ORE - TRAFFIC: January 2026 Proposed PIS & SCD's Updates Summary

Each SCD is bookmarked in this document for easier navigation to drawing of interest

OFFICE OF ROADWAY ENGINEERING	
DESIGNED	XXX
REVISION DATE	07-18-2014
CHECKED	XXX
REVIEWED	XXX
PLAN INSERT SHEET	
UNINTERRUPTIBLE POWER SUPPLY (UPS) AND CONTROLLER CABINET FOUNDATION	
PIS 208320	
1	1

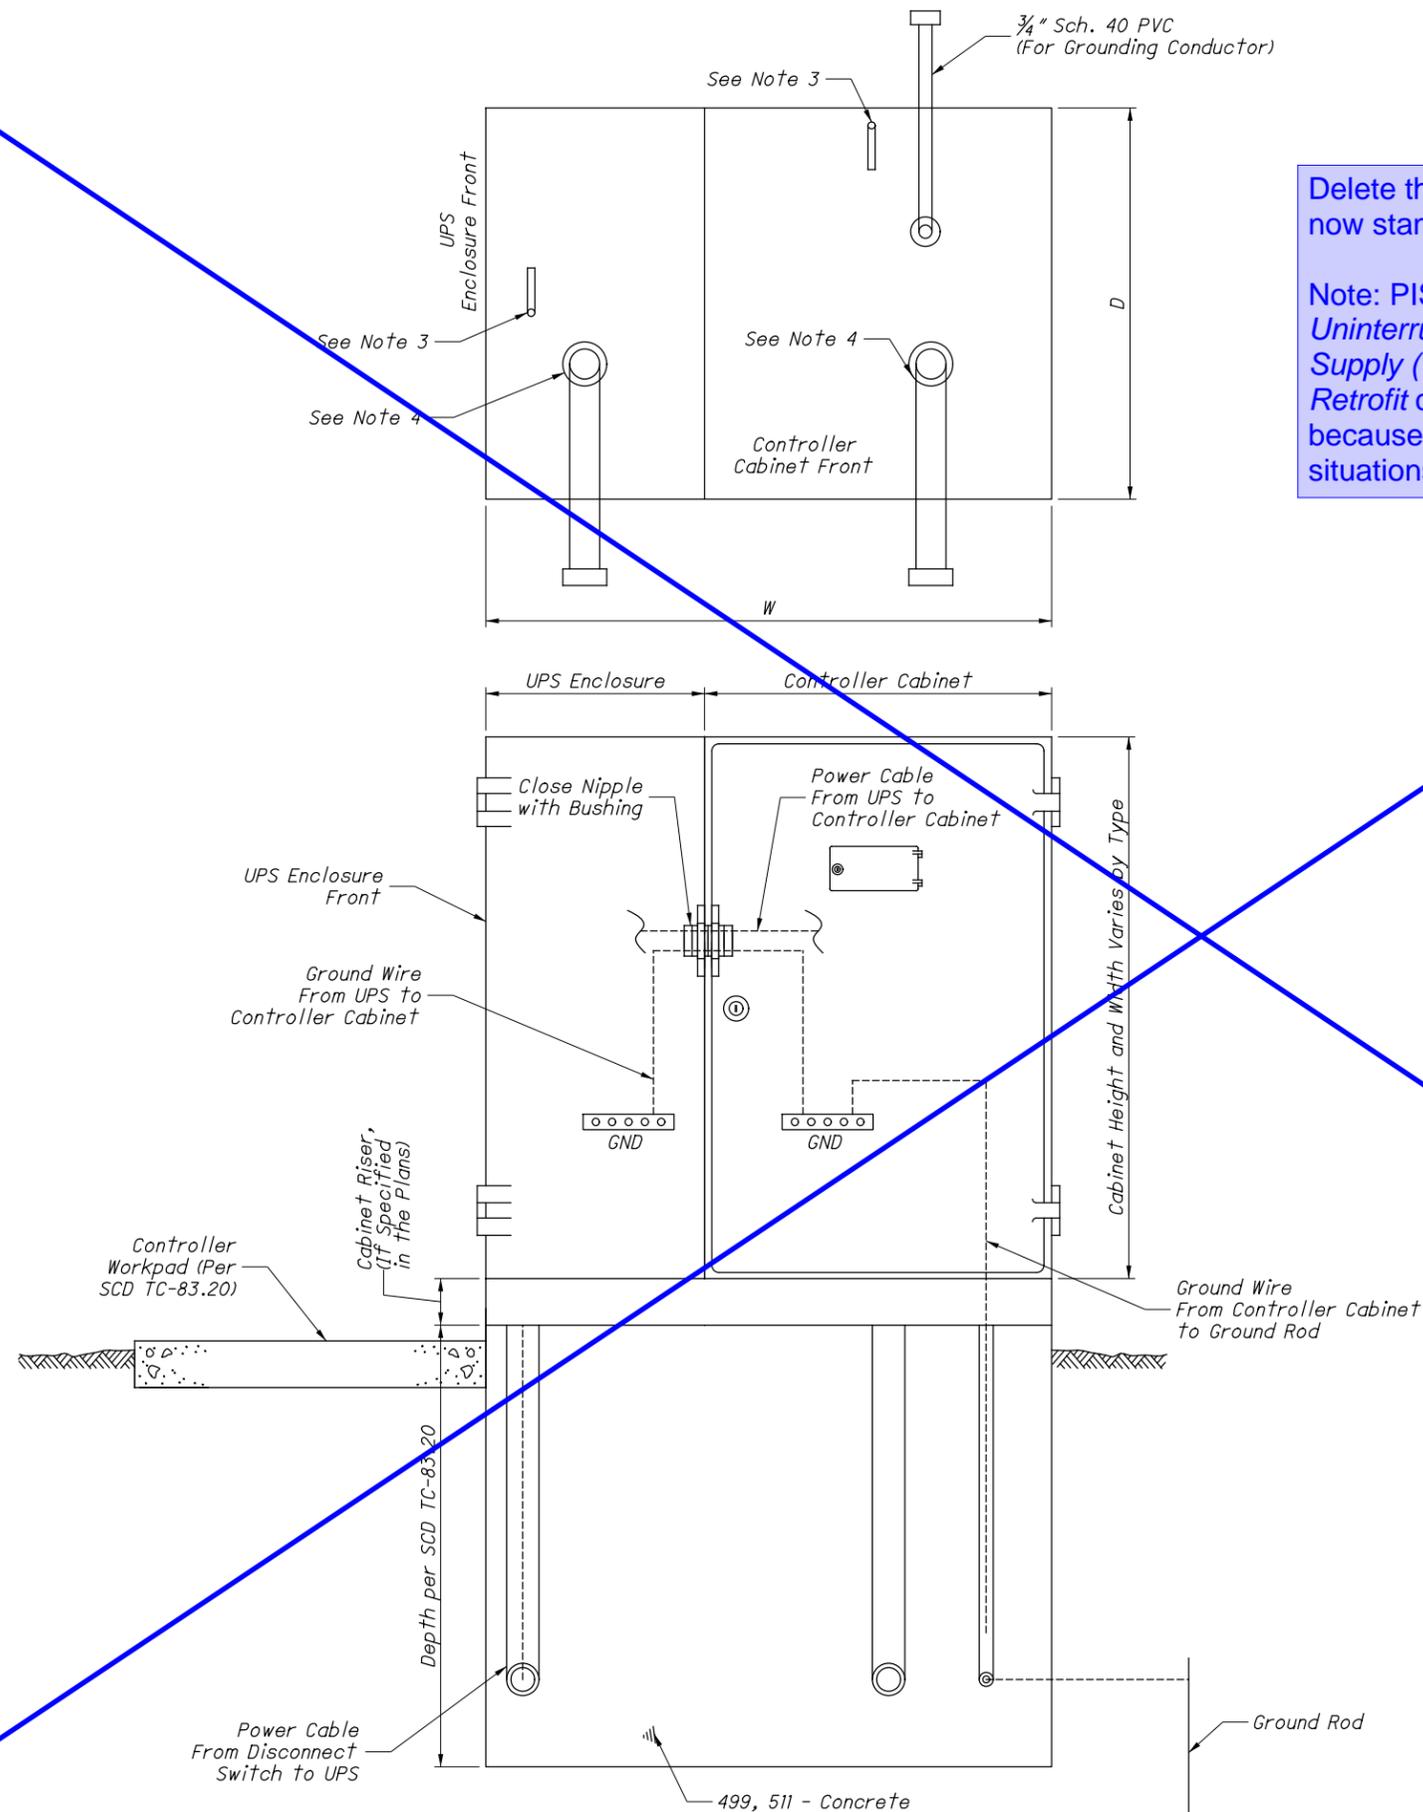
Delete this PIS. UPS are now standard in TC-83.20

Note: PIS 208321, Uninterruptible Power Supply (UPS) Foundation Retrofit can remain because it is for retrofit situations

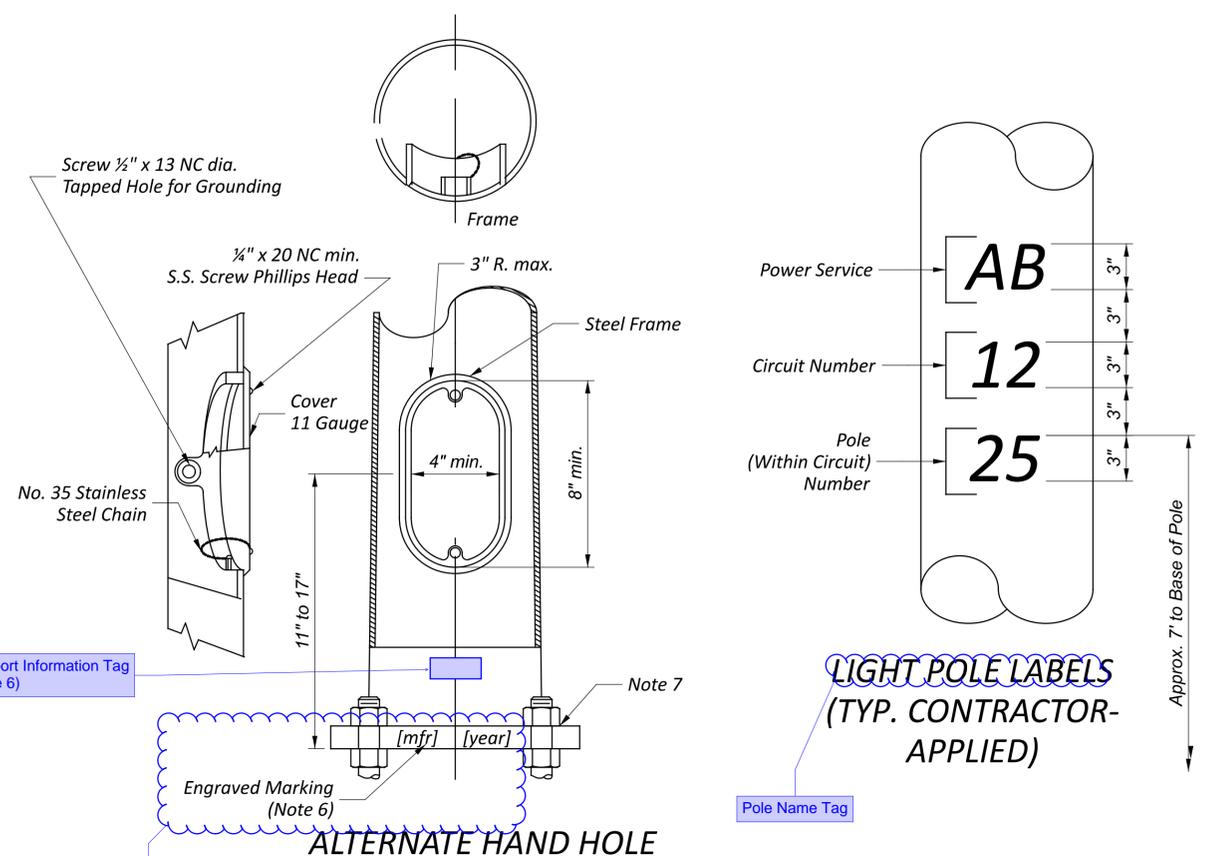
Replace with: Pole Name Tags shall be per C&MS 725.21, with details per the Lighting plan sheets.

HL-60.31
 MODEL: Sheet 3 PAPER SIZE: 34x22 (in.) DATE: 5/30/2025 TIME: 8:33:12 AM USER: kduemmel
 pw:\ohiodot-pw.bentley.com\ohiodot-pw-02\Documents\03 Standards\Pls_SCD\Traffic Control\Working Folder\Sandbox\KRD_Scratch\HL-60.31_KRD edits for Jan_2026.dgn

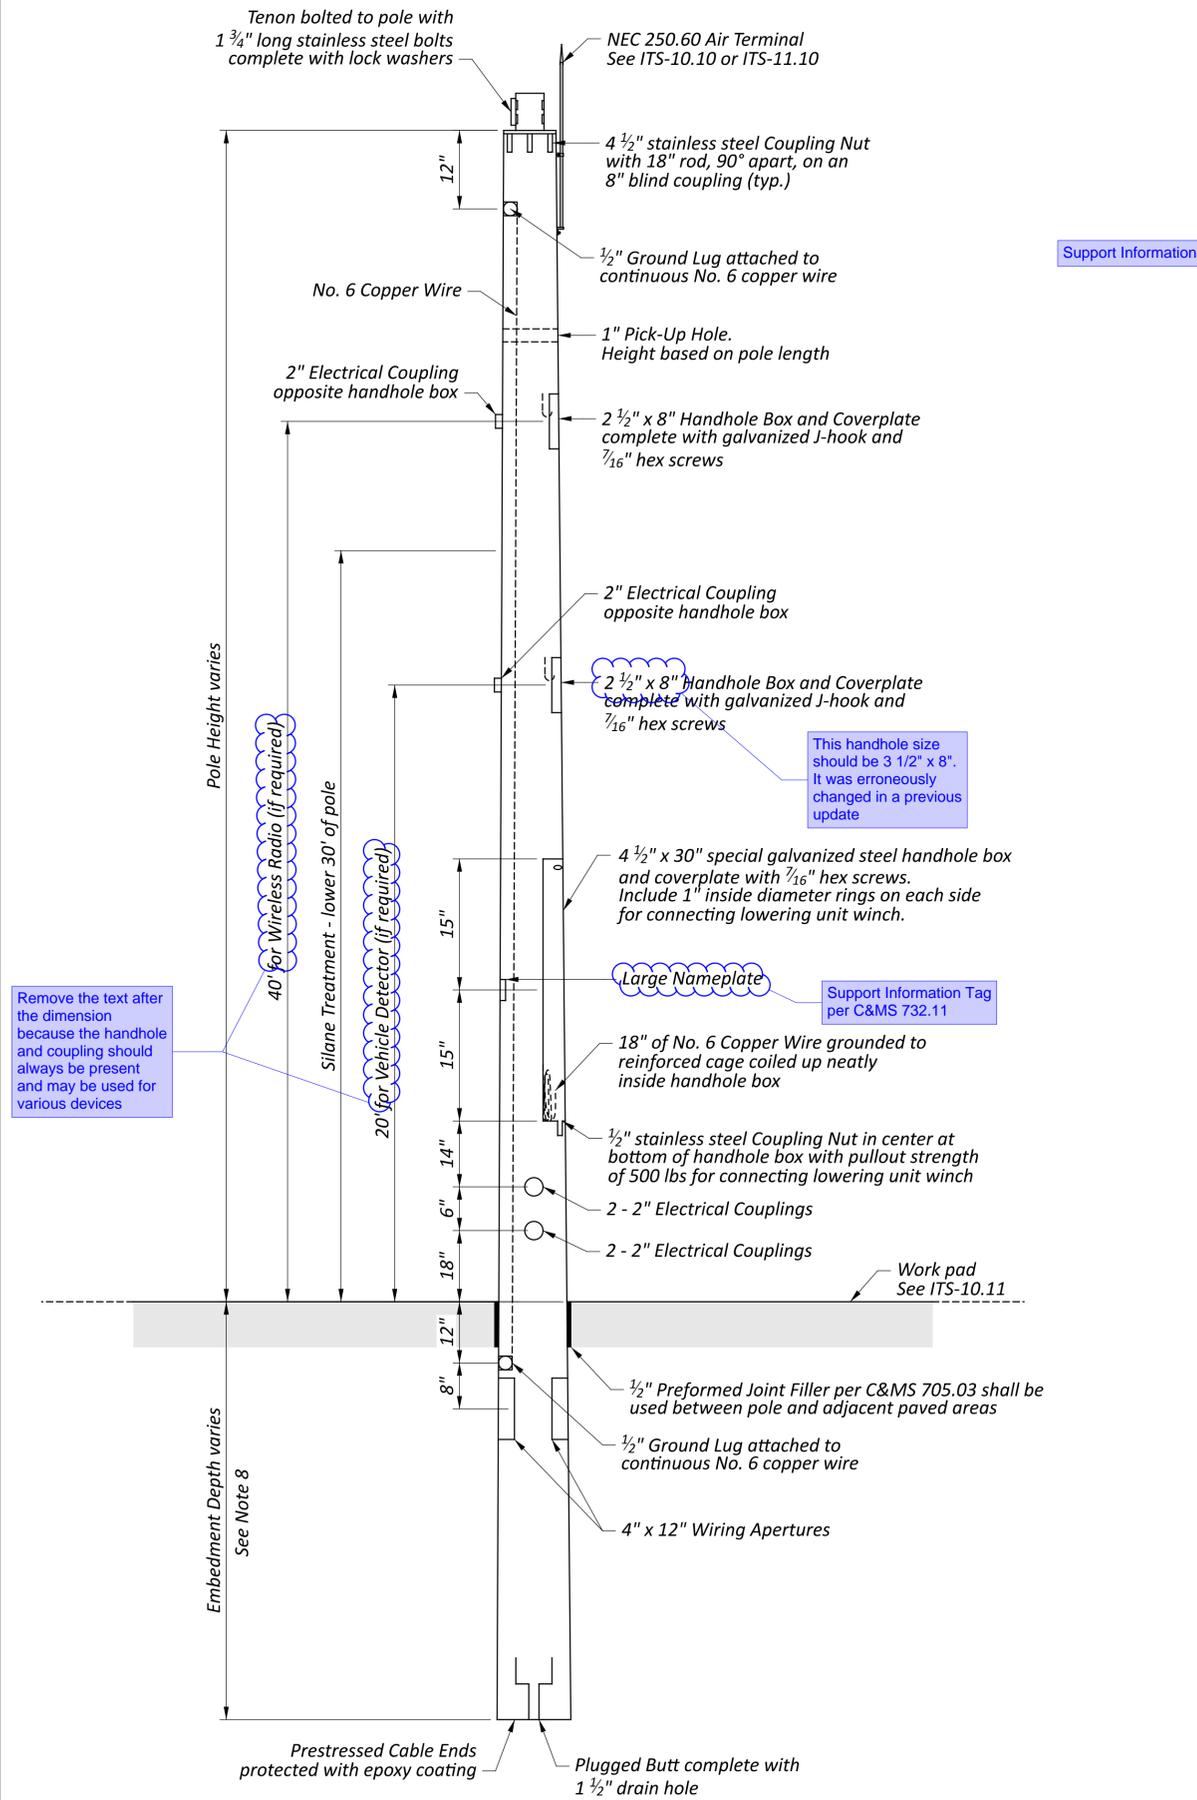
Remove the text after the dimension because the handhole and coupling should always be present and may be used for various devices

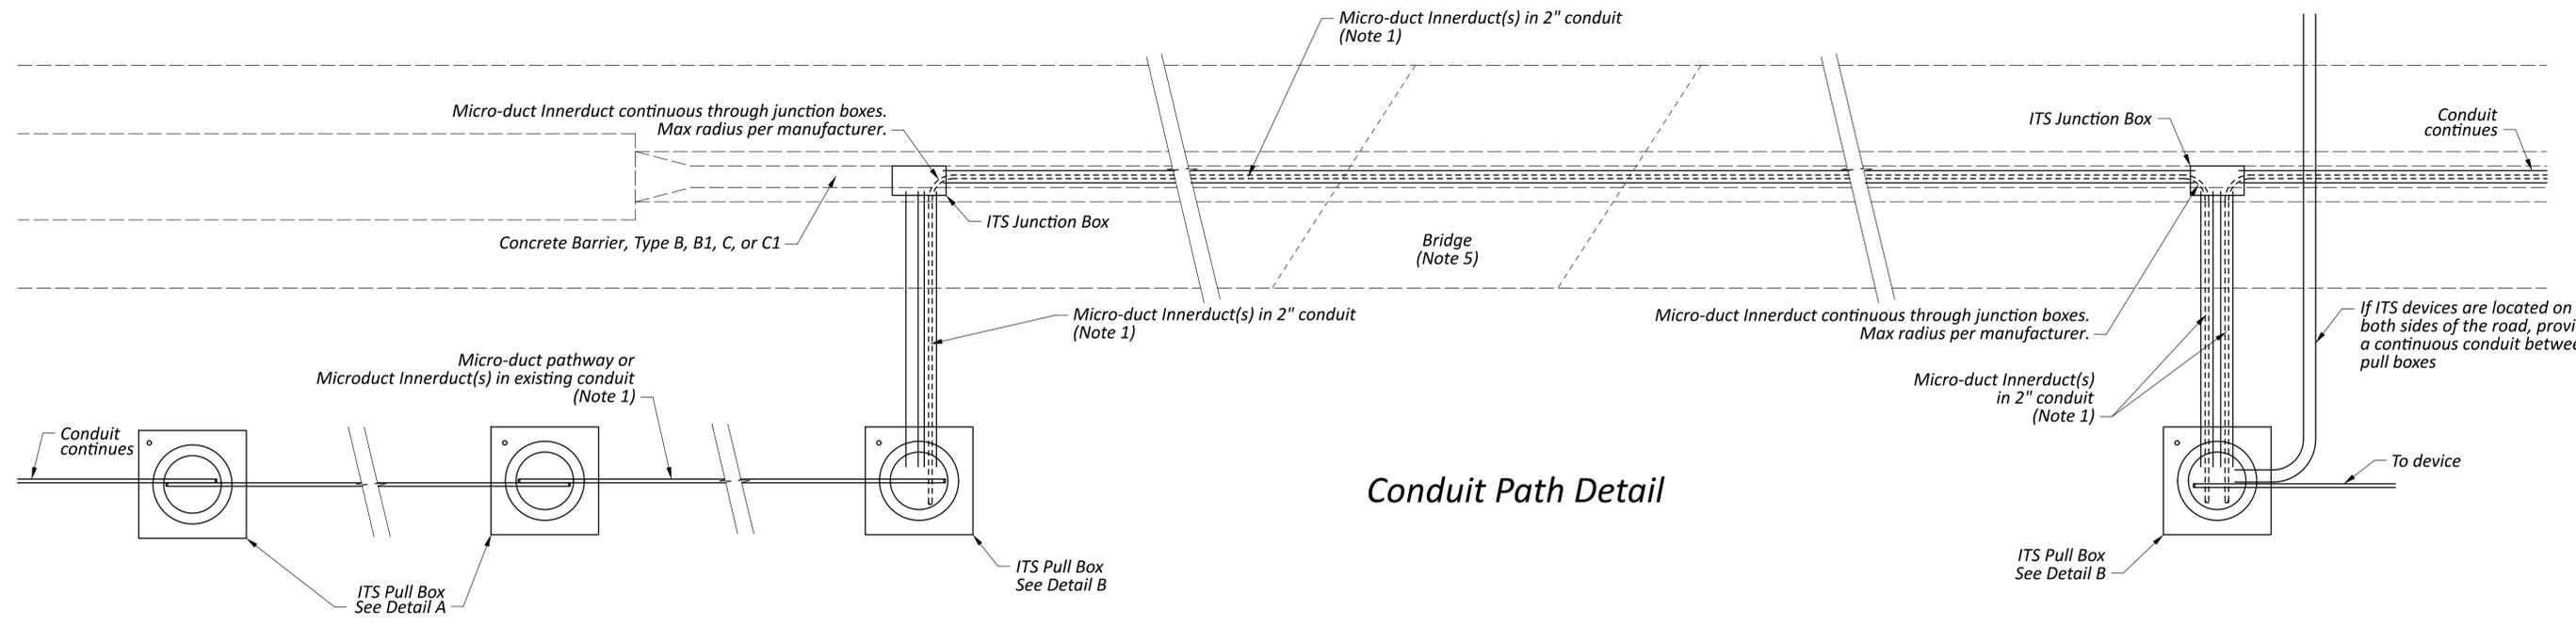
"Install communication cable markers on the high side of the slope.
Install hinged pull box lids so that the lid swings towards the bottom of the slope (i.e. hinge on the low side)."
Reason:
Communication cable marker makes it difficult to open the lid (regardless of hinge or not) when placed on the low side

120/ 240V, 3-WIRE, 1-PHASE POLE MOUNTED POWER SERVICE

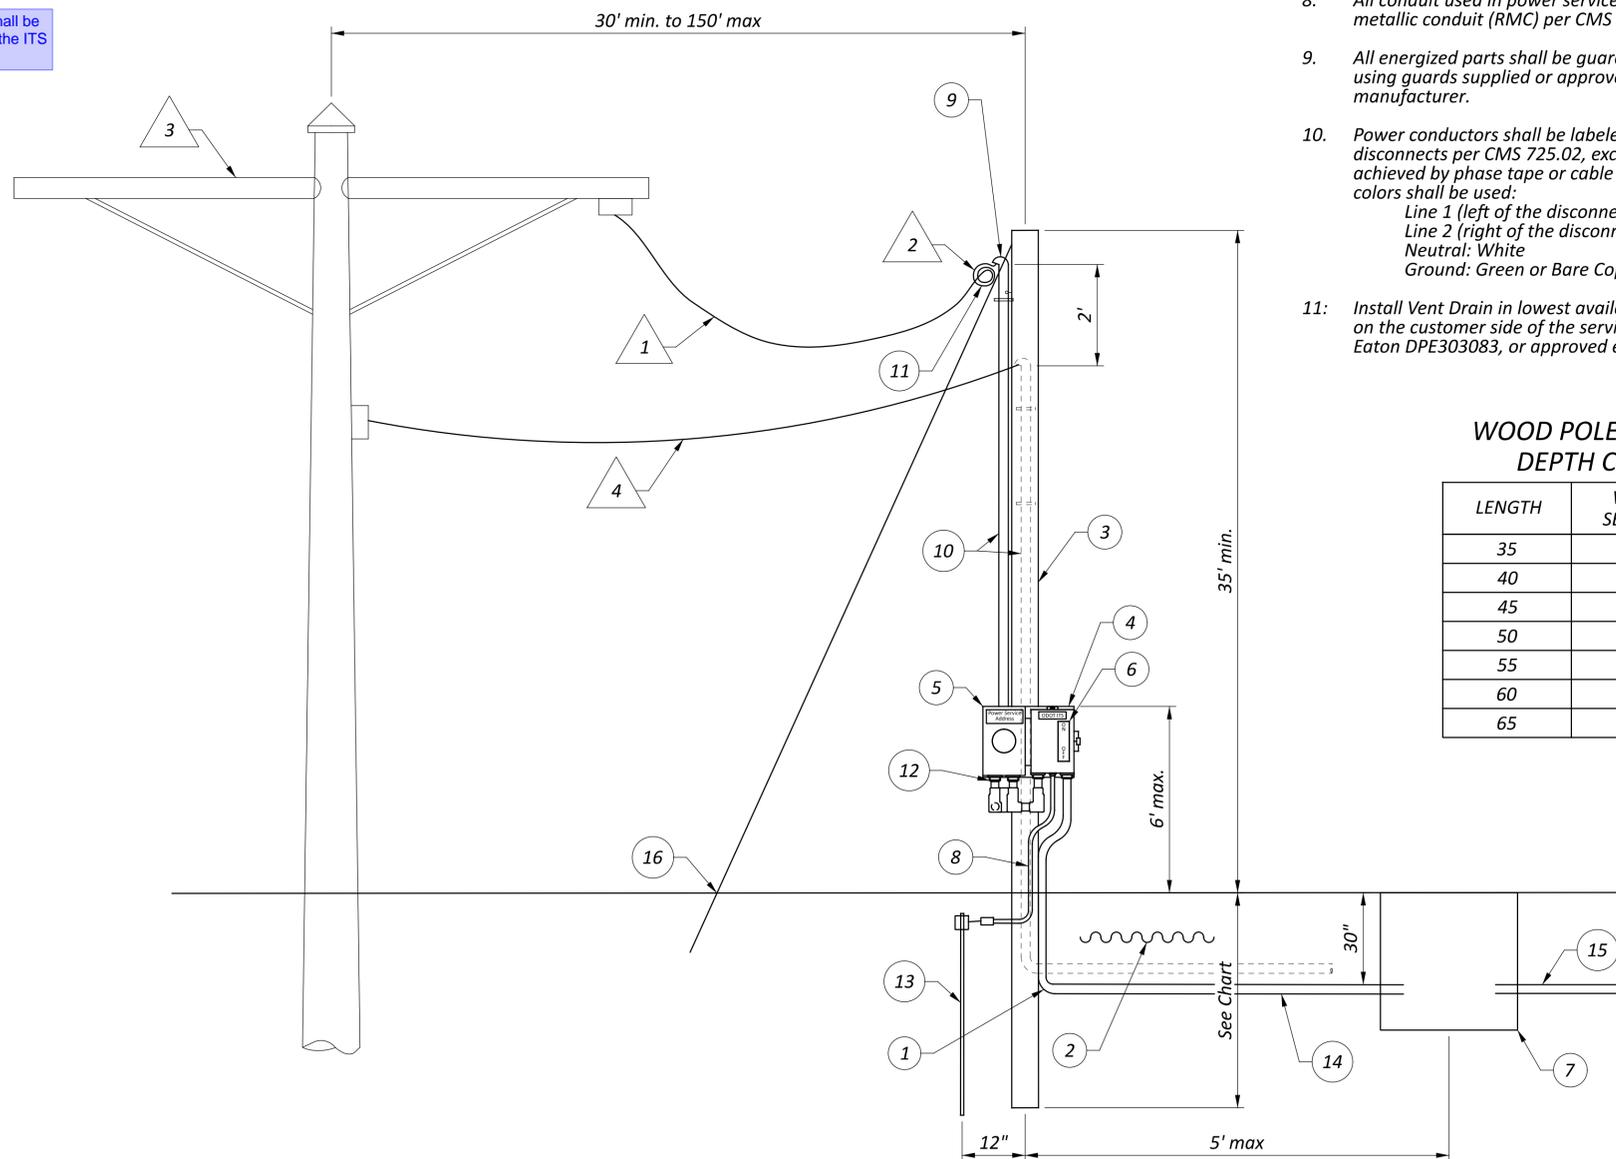
Remove 240/ 480V power services as an option for pole-mounted. The power industry is moving towards CT metering for 480V services, which will not fit easily on a pole

MAST ARM ELEVATION VIEW
2-LANE RAMP

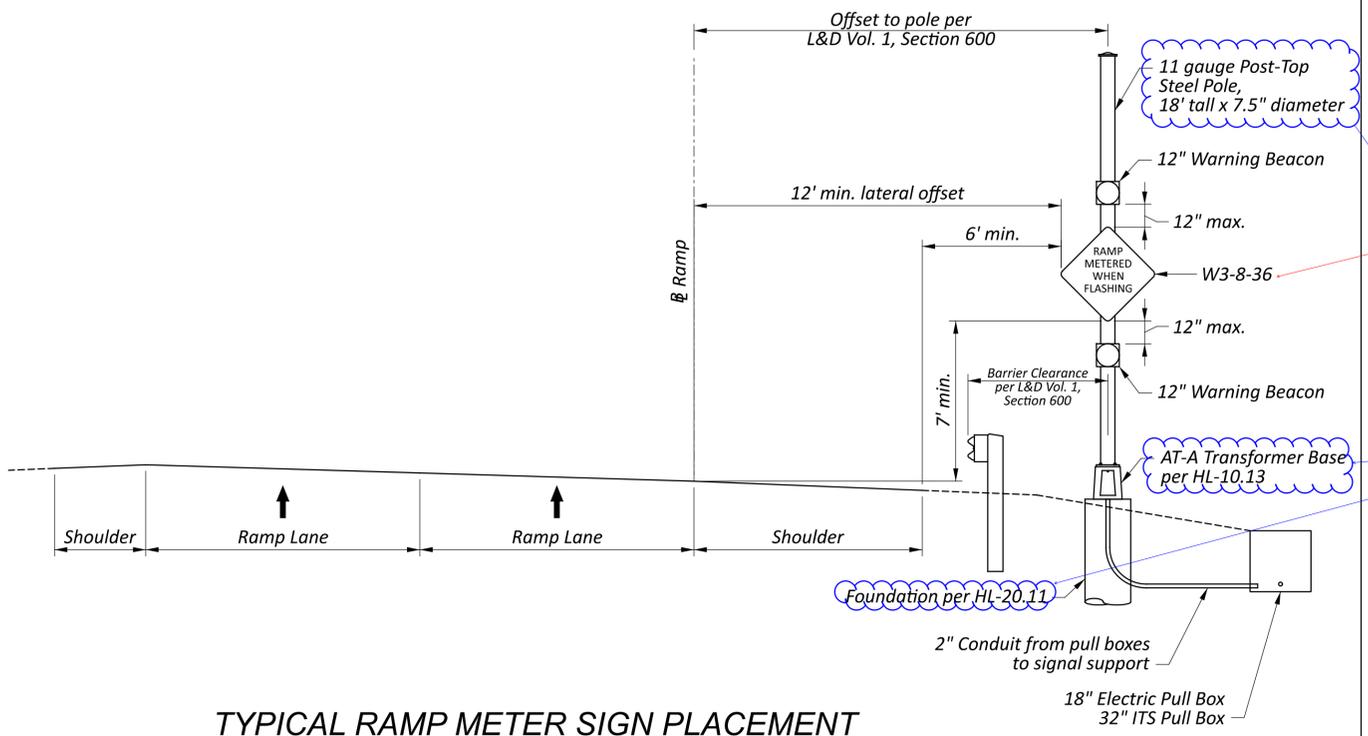
Change to:
17.5ft pedestal, base, and foundation per TC-83.30.
Reason: TC-83.30 has been updated with new standard pedestal designs
